World Forum for Harmonization of Vehicle Regulations

Proposal for Supplement 2 to the 04 series of amendments to UN Regulation No. 117 (Tyre rolling resistance, rolling noise and wet grip)

Submitted by the Working Party on Noise and Tyres*

Figure 1
Nomenclature explanation related to grip index of the tyre

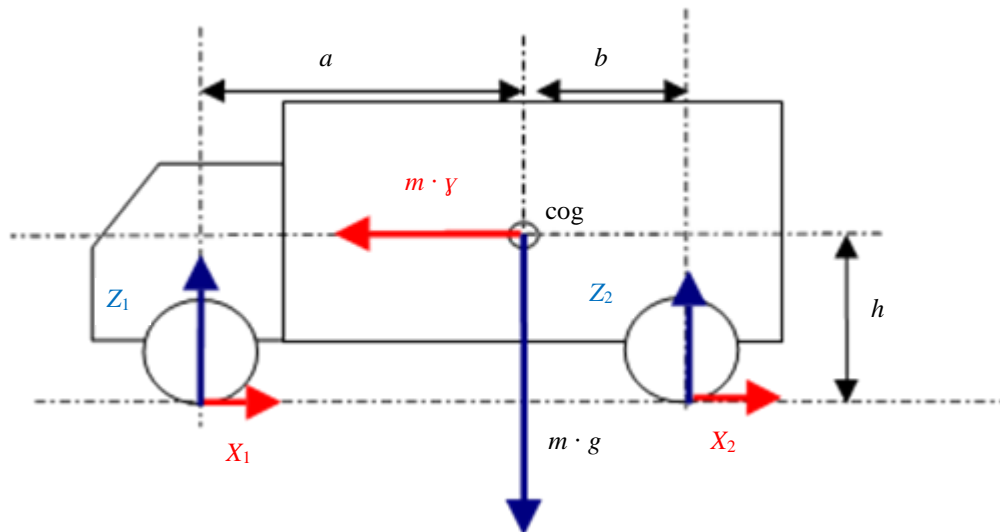
Paragraph 2.2.2.7.5., amend to read:

"2.2.2.7.5. Calculation of the relative wet grip index of the tyre

The wet grip index represents the relative performance of the candidate tyre compared to the reference tyre. The way to obtain it depends on the test configuration as defined in paragraph 2.2.2.2. of this Annex. The wet grip index G of the tyre is calculated as reported into Table 7:

Configuration C1: candidate tyres on both axles	$G = f \cdot \frac{BFC(T)}{BFC(R)}$
Configuration C2: candidate tyres on front axle and reference tyres on rear axle	$G = f \cdot \frac{BFC(T) \cdot [a + b + h \cdot BFC(R)] - a \cdot BFC(R)}{BFC(R) \cdot [b + h \cdot BFC(T)]}$
Configuration C3: reference tyres on front axle and candidate tyres on rear axle	$G = f \cdot \frac{BFC(T) \cdot [-a - b + h \cdot BFC(R)] + b \cdot BFC(R)}{BFC(R) \cdot [-a + h \cdot BFC(T)]}$

Where (see also Figure 1):

- f : correction factor depending on used SRTT
- cog : centre of gravity of the loaded vehicle
- m : mass (in kilograms) of the loaded vehicle

- a : horizontal distance between front axle and centre of gravity of the loaded vehicle (m)
- b : horizontal distance between rear axle and centre of gravity of the loaded vehicle
- h : vertical distance between ground level and centre of gravity of the loaded vehicle (m).
- N.B.* When h is not precisely known, these worst case values shall apply: 1.2 for configuration C2, and 1.5 for configuration C3
- γ : loaded vehicle acceleration [$m \cdot s^{-2}$]
- g : acceleration due to the gravity [$m \cdot s^{-2}$]
- X_1 : longitudinal (X-direction) reaction of the front tyre on the road
- X_2 : longitudinal (X-direction) reaction of the rear tyre on the road
- Z_1 : normal (Z-direction) reaction of the front tyre on the road
- Z_2 : normal (Z-direction) reaction of the rear tyre on the road

Figure 1

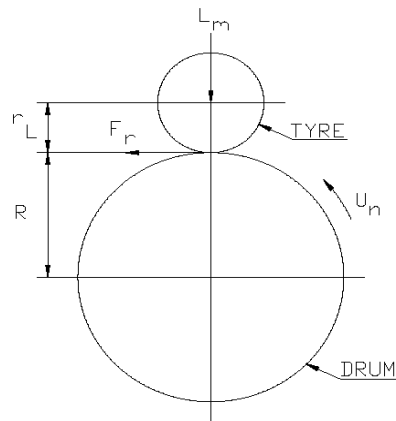
Paragraph 4.5., amend to read:

"4.5. Measurement and recording

The following shall be measured and recorded (see Figure 1):

- (a) Test speed U_n ;
- (b) Load on the tyre normal to the drum surface L_m ;
- (c) The initial test inflation pressure as defined in paragraph 3.3. above;
- (d) The coefficient of rolling resistance measured C_r , and its corrected value C_{rc} , at 25 °C and for a drum diameter of 2 m;
- (e) The distance from the tyre axis to the drum outer surface under steady state r_L ;
- (f) Ambient temperature t_{amb} ;
- (g) Test drum radius R ;
- (h) Test method chosen;
- (i) Test rim (size and material);
- (j) Tyre size, manufacturer, type, identity number (if one exists), speed category symbol, load index, DOT number (Department of Transportation).

All the mechanical quantities (forces, torques) will be orientated in accordance with the axis systems specified in ISO 8855:2011.

The directional tyres shall be run in their specified rotation sense."
